## Product Change Notice (PCN)

**Subject:** Part Marking Change for the Listed Intersil HSx-1840xxH / DLA SMD 5962-95630 Products

**Publication Date:** 8/18/2015

Appendix B:

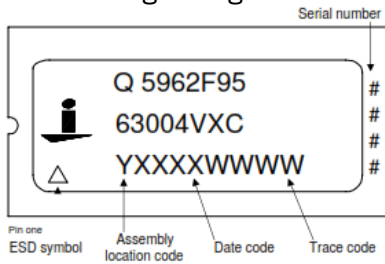
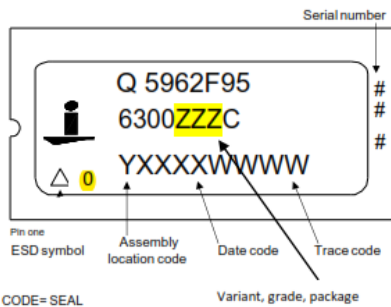
Modify HSx-1840xxH Brand to add ESD class code as defined in MIL-STD-883 TM3015 Table III.

Provide unit level identifier showing the ESD rating/sensitivity of this particular product. There is NO change to the ESD rating of the product.

New Marking Configuration (SBDIP shown as example, all versions to have a 0 after ESD symbol – see MIL-PRF-38535 para: )
